**Marion County
Board of County Commissioners**

**PLANNING & ZONING SECTION
STAFF REPORT**

P&ZC Date: 10/28/2024	BCC Date: 11/19/2024
Case Number:	241108ZP	
CDP-AR:	31946	
Type of Case:	Rezoning from General Agriculture (A-1) to Planned Unit Development (PUD) for 213 residential units (single family detached), total not to exceed 236 units.	
Owner	GUT Einhaus LLC	
Applicant	Tillman & Associates Engineering, LLC	
Street Address	2486 NW 60TH Ave, Ocala, FL 34482	
Parcel Number	21615-000-00	
Property Size	±59.11 acres	
Future Land Use	Medium Residential (MD)	
Zoning Classification	General Agriculture (A-1)	
Overlay Zone/Scenic Area	Urban Growth Boundary, Secondary Springs Protection Zone, and portions in Flood Prone Areas	
Staff Recommendation	DENIAL	
P&ZC Recommendation	No Recommendation (3 – 3)	
Project Planner	Xinyi Cindy Chen	
Related Case(s)	Previous PUD application: Motion for Approval failed by 2 Aye and 3 Nye. (210402Z – Rezoning from A-1 to PUD for 207 SFR units)

Figure 2
Conceptual Plan (submitted on Nov. 4th, 2024)

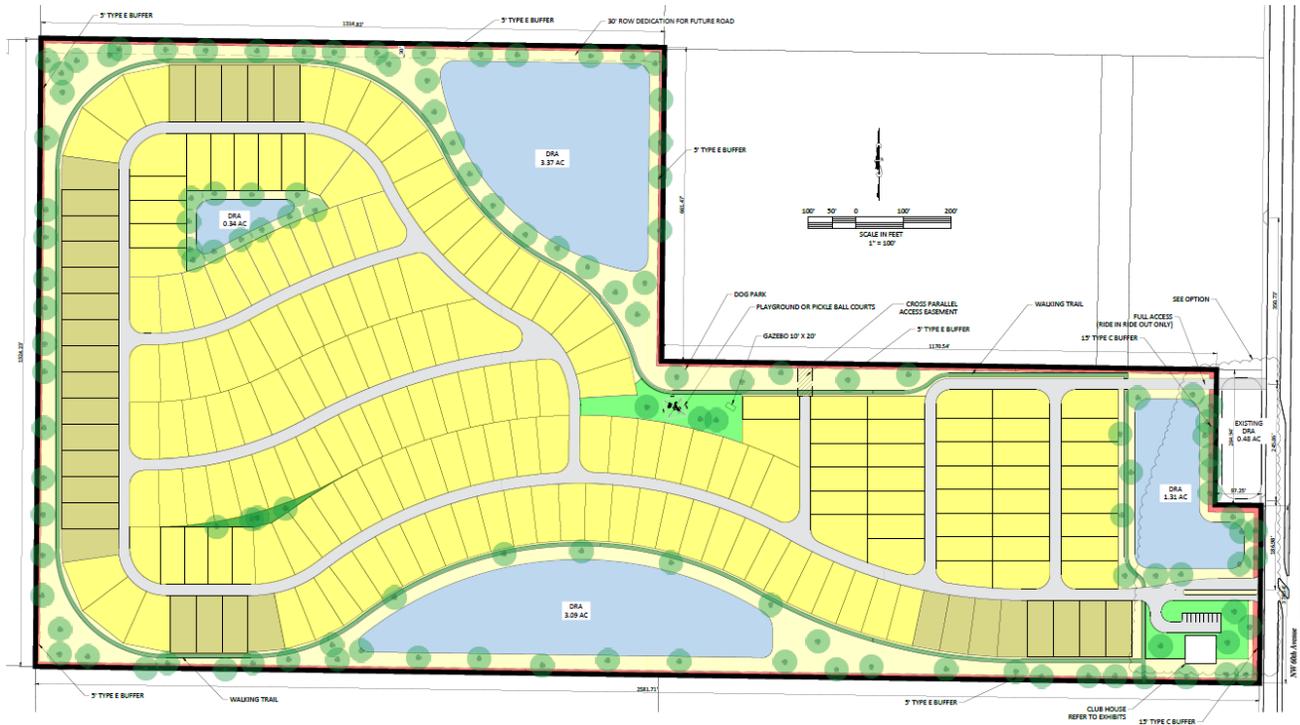
- 1. Landlocking parcels:** Several surrounding parcels currently lack roadway access, and the proposed concept plan does not provide opportunity or potential solution to address this. The Land Development Code (LDC) requires that each parcel must have at least one access point to a roadway. Thus, ROW dedication and cross-access easements are needed for future development on adjacent properties. Per OCE Traffic comments, the plan does not address the landlocking issues. Staff recommends the following conditions:

- All internal and external vehicle circulation shall be paved.
- 2. Sidewalk:** The current plan lacks internal sidewalks or multimodal facilities, as required by the Land Development Code (LDC), which mandates at least one sidewalk along internal roads. Accessible sidewalks are necessary; trails alone do not fulfill this requirement. Staff recommends the following conditions:

3. **Access:** The current plan channels all traffic to NW 60th Ave. A secondary full-access point to another major roadway is recommended. Staff recommends:

4. **Buffer:** The concept plan proposes a 5-foot-wide Type E buffer between the proposed single-family residential (SFR) area and existing agricultural uses, meeting minimum LDC requirements. However, adjacent properties feature active farming with cattle and horses. Staff recommends the following conditions to the boundary between development and existing agricultural lands:

For the buffer on the east side along NW 60th Ave and around the County-maintained DRA, the concept plan proposes a 15'-wide Type C buffer, which meets the LDC minimal requirement. Staff recommends the same.

Analysis: Access to the property is shown on the conceptual plan. One full access and one emergency access are proposed on the subject parcels. According to the DRC comments, there are several major concerns: The traffic study indicated a southbound right turn lane is required at the main entrance to the subdivision. This will require a right-of-way dedication along NW 60th Avenue. Also, there are several large landlocked parcels with residential zoning adjacent to this property. Connections should be stubbed out to these parcels to allow for future connections. This issue was a concern in the previous PUD application and contributed to its denial. Furthermore, staff recommends a second full access to public roadway.

Analysis: As discussed above, the project does not propose sidewalk on internal or external roadways, except portion along NW 60th Ave (or pay fee in lieu of construction). LDC requires at least one-side sidewalk to be provided along roadways internally and externally. Moreover, multimodal facilities are not proposed. According to DRC comments, multimodal design accommodating pedestrian, bicycle, transit, and vehicular access is recommended to provide for PUD development. DRC comments also point out the deficiency in roadway width: The proposed cross section shows 40' of right-of-way and 5' easements, while the standard requirement is 50' of right-of-way with 5' easements to accommodate the roadway, drainage, sidewalk, and utilities. The cross section does not demonstrate how all these elements will fit within the reduced space. Based on the concerns regarding lack of multimodal facilities, internal roadway width, and sidewalk placement, staff recommends denial to the proposed PUD concept plan. If the PUD is approved, staff recommends the following conditions be imposed:

Analysis: Building height limitation is shown on the Concept Plan (see Attachment A). However, the typical elevation illustration showing height limits is not provided in the submittal.

Analysis: As discussed above, the concept plan proposes a reduced 40-foot right-of-way instead of the required 50 feet, which is insufficient to accommodate the necessary roadway, drainage, sidewalks, and utilities. Furthermore, no multimodal facilities, such as bike lanes or pedestrian pathways, are included. This directly conflicts with the objective's mandate to ensure adequate rights-of-way for roadways, transit, bicycle, and pedestrian pathways, as well as to protect future rights-of-way from encroachment. The lack of space and multimodal provisions compromises the County's ability to meet these future needs. Thus, the proposed PUD is **inconsistent** with Comprehensive Plan Objective 3.1.2 on Adequate Rights of Way/Encroachment.

- Provide a connection to the right-of-way on the northwest and to allow future connection for adjacent parcels on the north.
 - All access point locations, ingress/egress, right-of-way dedication, easement, and connection to adjacent properties shall be worked out to the satisfaction of the Development Review Committee (DRC) during the time of Development Review before the Site Plan approval.

- Show multimodal facilities on the PUD Master Plan. Include multimodal path for pedestrians and bikes externally and internally.
 - Show accessible pedestrian connections from PUD area to adjacent land uses on the site plan.

- Show accessible sidewalks along at least one side of internal roads and along NW 60th Ave and connections to multimodal paths.
 - Show parking calculation on the site plan.

- Provide a second full access for the development.
 - All access point locations shall be worked out to the satisfaction of the Development Review Committee during the time of Development Review before the Site Plan approval.

- Buffers shall be provided as shown in concept plan,
 - Buffers along the perimeter shall use 7-gallon, 3-foot high plants, at the time of planting, and use 4-inch caliper trees at the time of planting.

- Buffer type and its illustration shall be submitted with the site plan phase for approval.
 - Buffer type and its illustration shall be submitted with the site plan phase for approval.

- Provide a second full access for the development.
 - Provide a connection to the right-of-way on the northwest and to allow future connection for adjacent parcels on the north.
 - All access point locations, ingress/egress, right-of-way dedication, easement, and connection to adjacent properties shall be worked out to the satisfaction of the Development Review Committee (DRC) during the time of Development Review before the Site Plan approval.
 - All internal and external vehicle circulation shall be paved.
2. LDC Section 4.2.31.E.(1)(b) provides the PUD shall include pedestrian and/or bicycle facilities internally to address internal circulation needs and externally to provide for integration of the PUD to surrounding existing for future facilities.

- Show multimodal facilities on the PUD Master Plan. Include multimodal path for pedestrians and bikes internally as well as externally along NW 60th Ave.
 - Show accessible pedestrian connections from PUD area to adjacent land uses on the site plan.
 - Show accessible sidewalks along at least one side of internal roads and along NW 60th Ave and connections to multimodal paths.
3. LDC Section 4.2.31.E.(1)(c) provides the PUD shall include multimodal design accommodating pedestrian, bicycle, transit, and vehicular access focusing on integrating the modes with the proposed PUD uses and expected activity levels and/or focus (e.g., employment, residential, institutional, etc.).

- On the Master Plan provide a typical illustration and table showing a maximum height limits for principal and accessory structures.
3. LDC Section 4.2.31.E.(4)(b) addresses dissimilar uses.
